EAGLEVIEW REGIONAL DRAINAGE IMPROVEMENTS GRADING AND EROSION CONTROL PLAN

EPC STORMWATER REVIEW COMMENTS
IN ORANGE BOXES WITH BLACK TEXT

EAGLEVIEW REGIONAL DRAINAGE IMPROVEMENTS
EL PASO COUNTY, COLORADO
GRADING AND EROSION CONTROL PLAN
GESC COVER SHEET

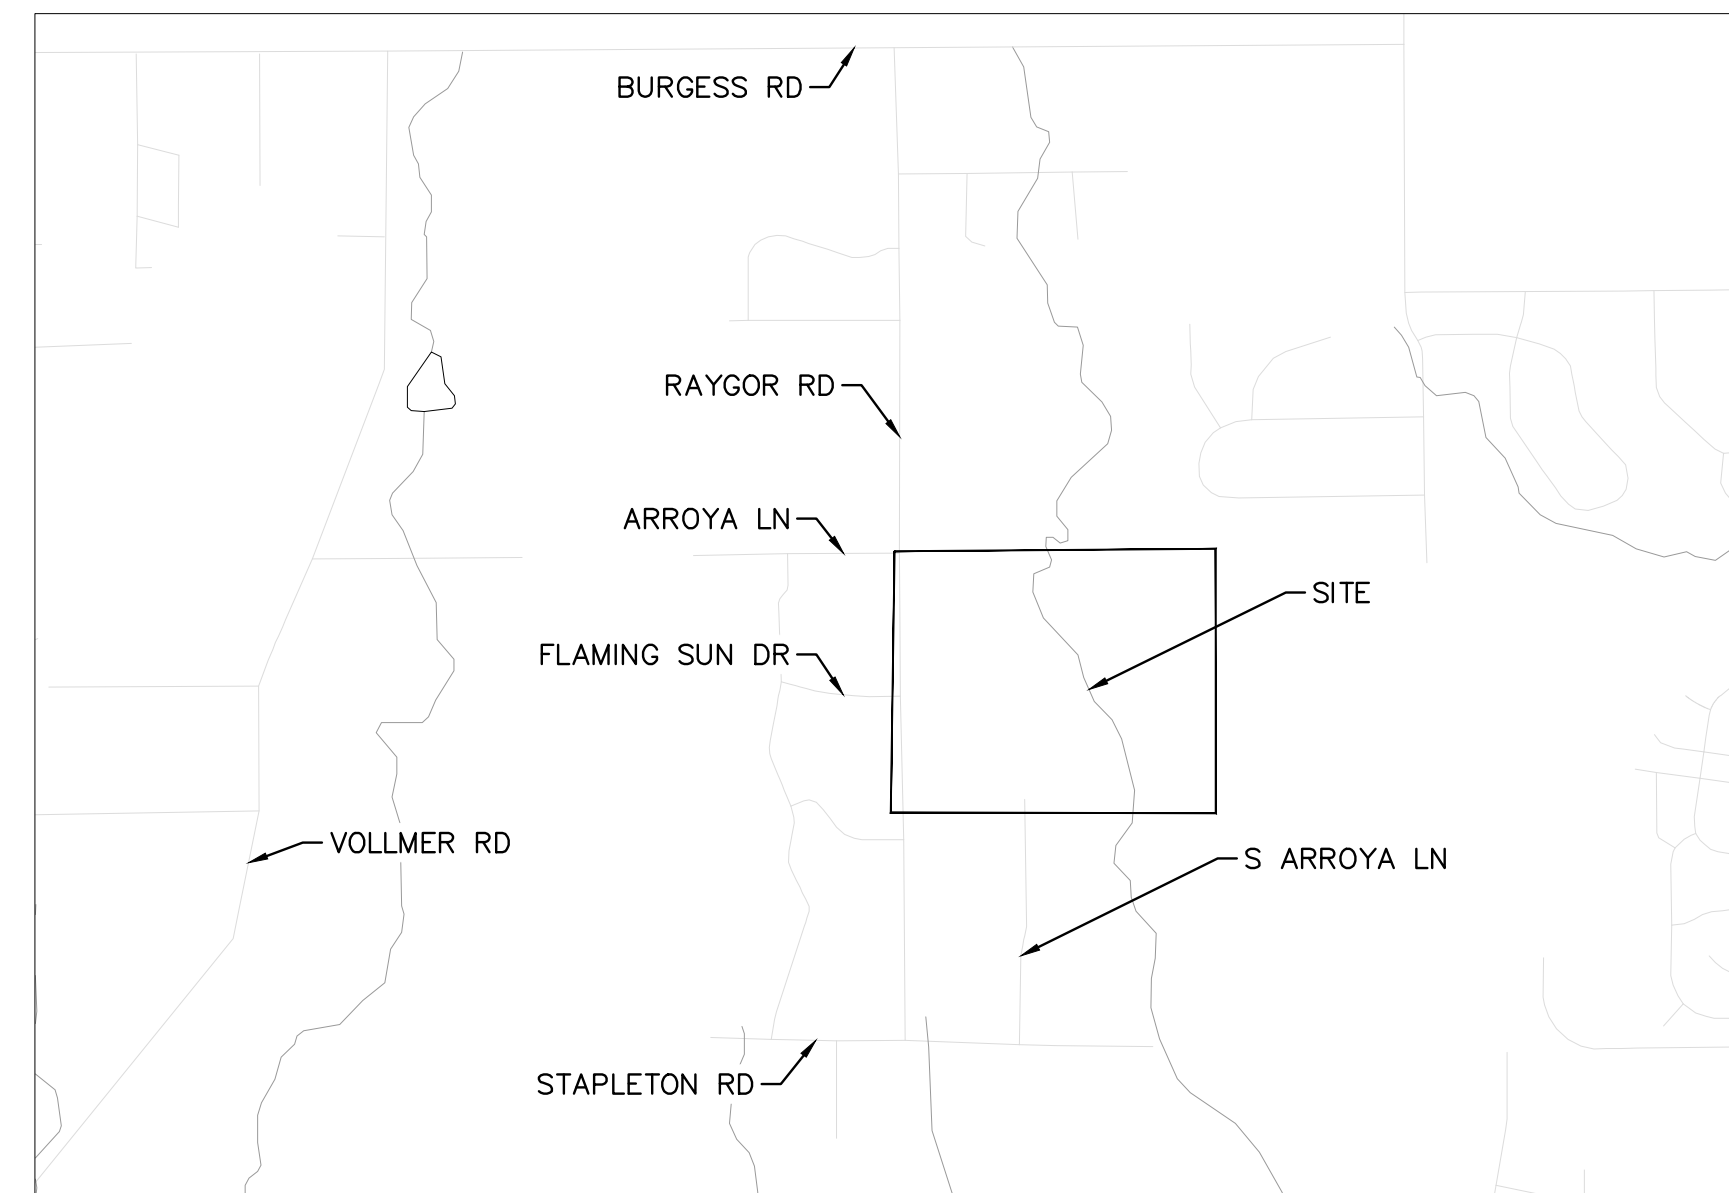
Please update. Ms. Ruiz no longer with County CHG to Ryan Howser (ryanhowser@elpasoco.com) (719) 520-6049

Add PCD File #
CDR238

EAGLEVIEW REGIONAL DRAINAGE IMPROVEMENTS
EL PASO COUNTY, COLORADO
GRADING AND EROSION CONTROL PLAN
INITIAL GESC PLAN

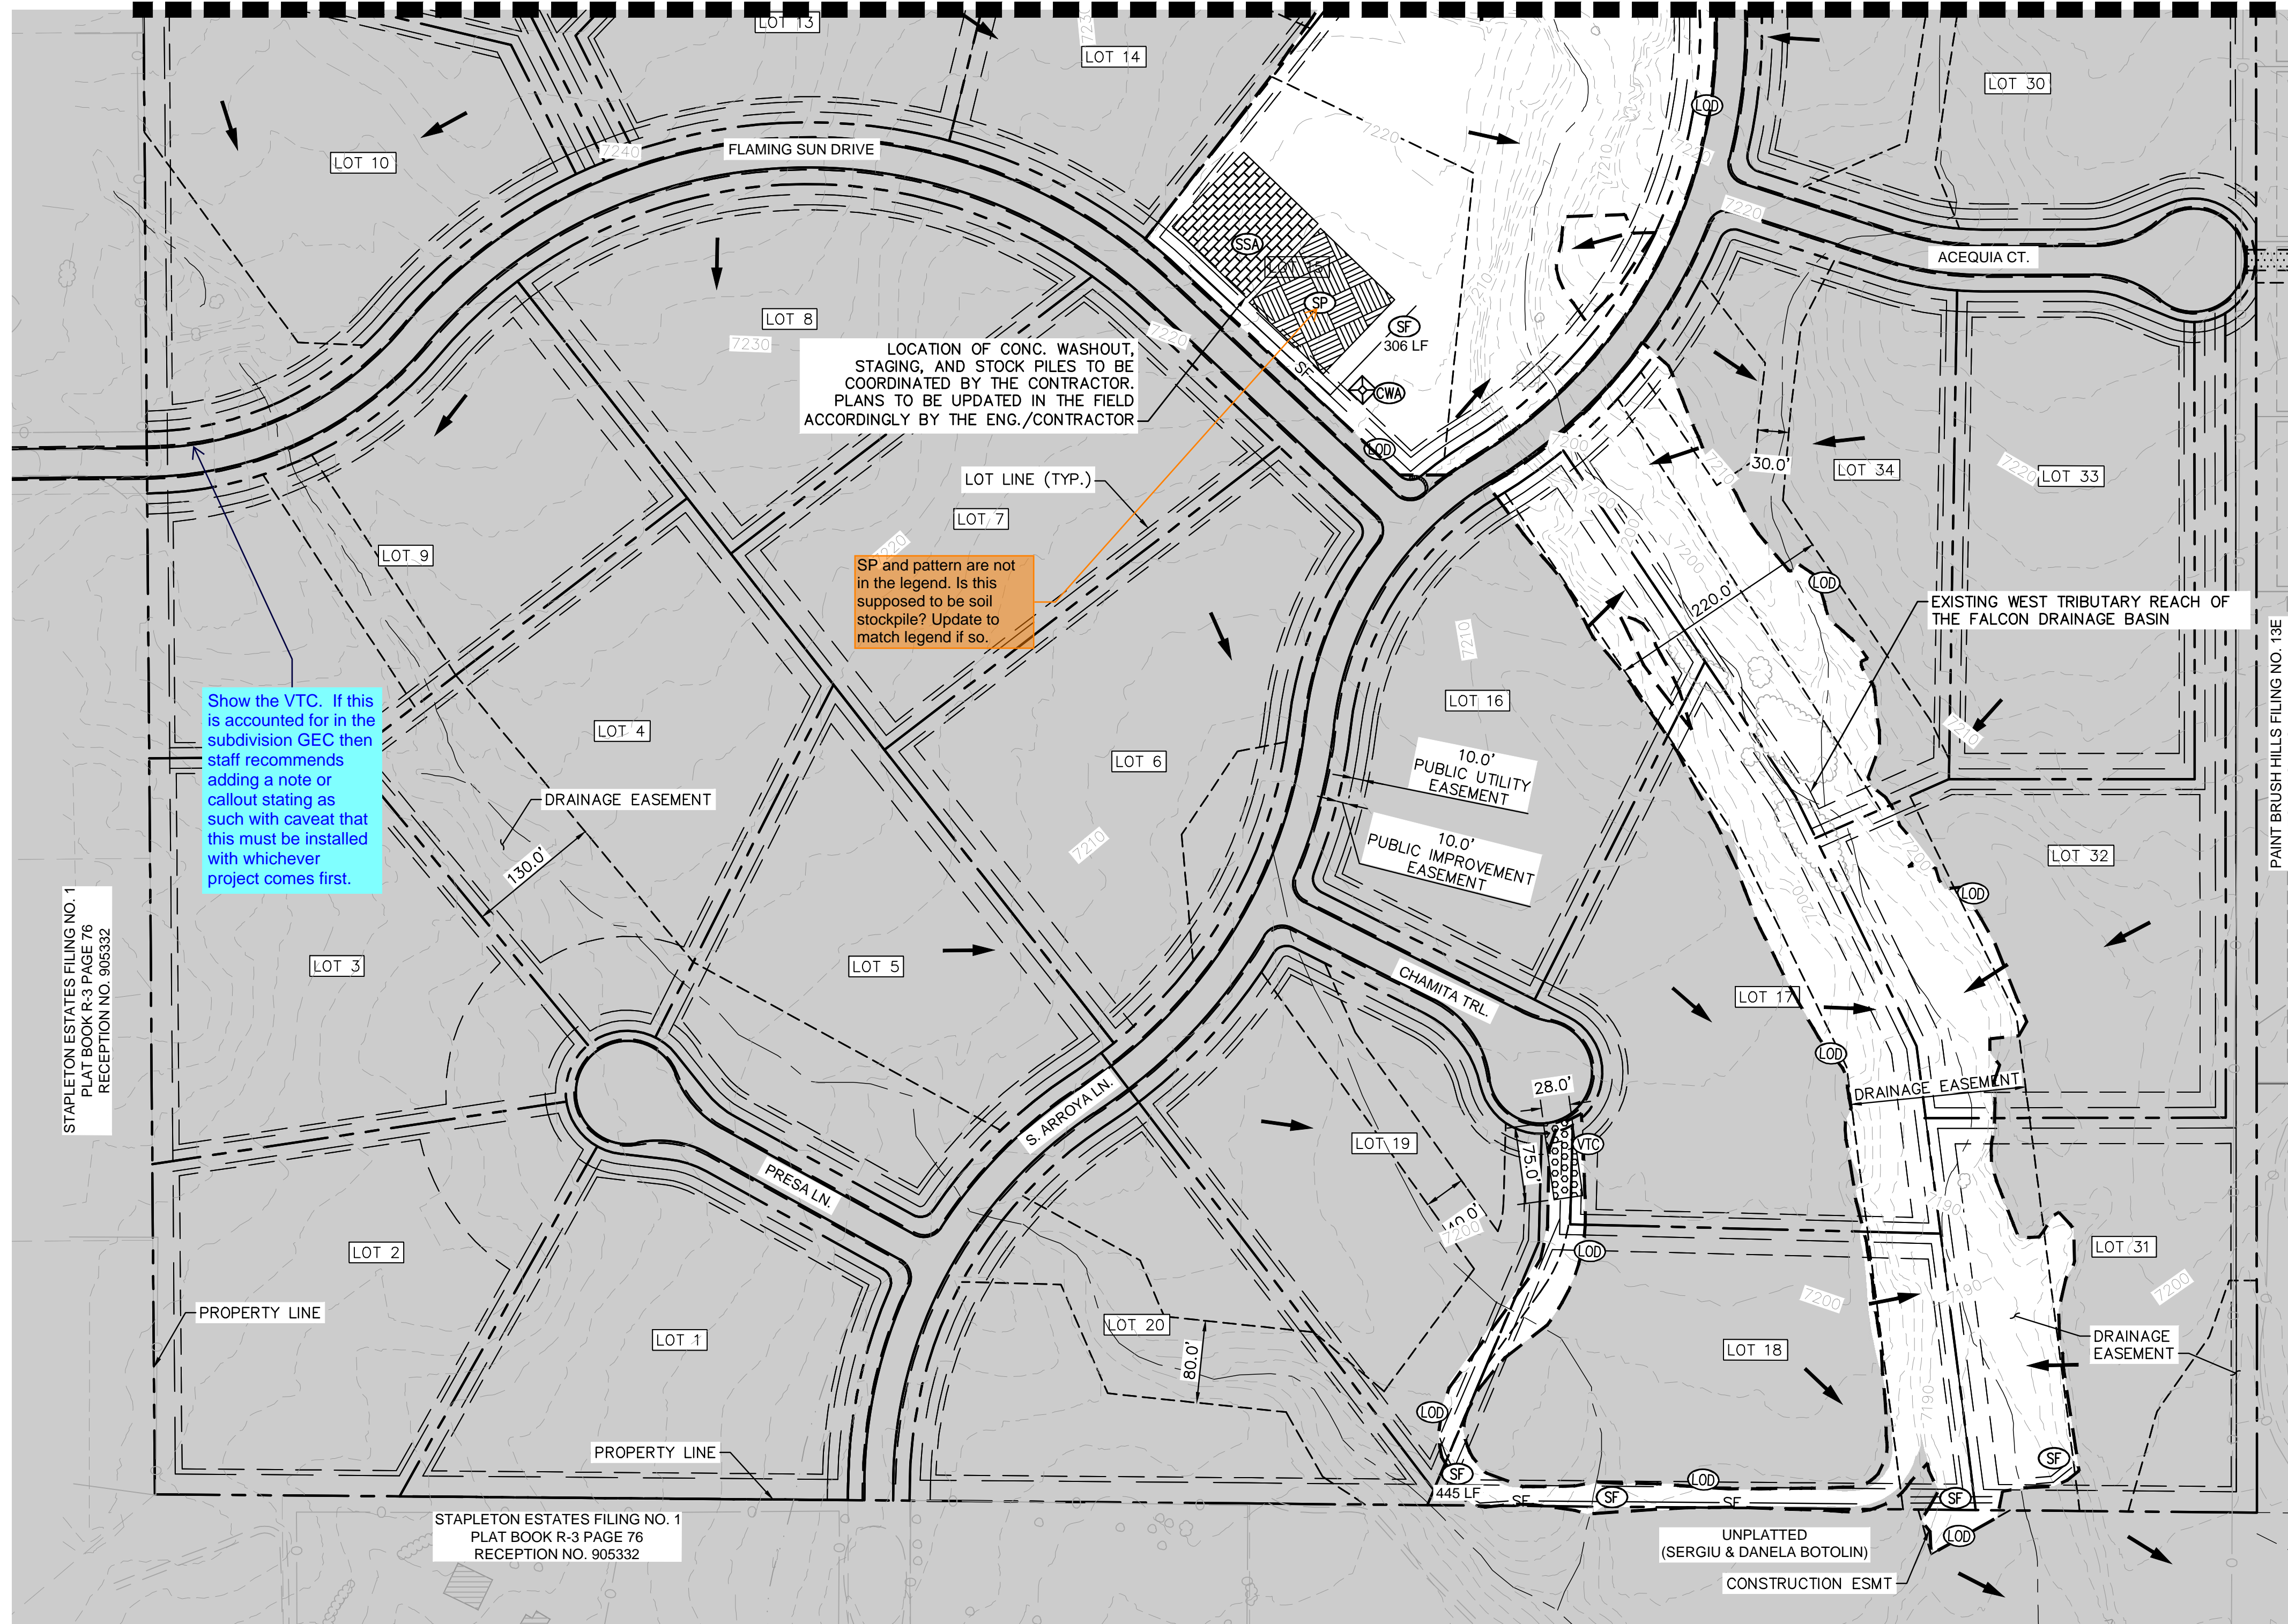
Show the VTC. If this is accounted for in the subdivision GEC then staff recommends adding a note or callout stating as such with caveat that this must be installed with whichever project comes first.

Provide geotechnical report for review.
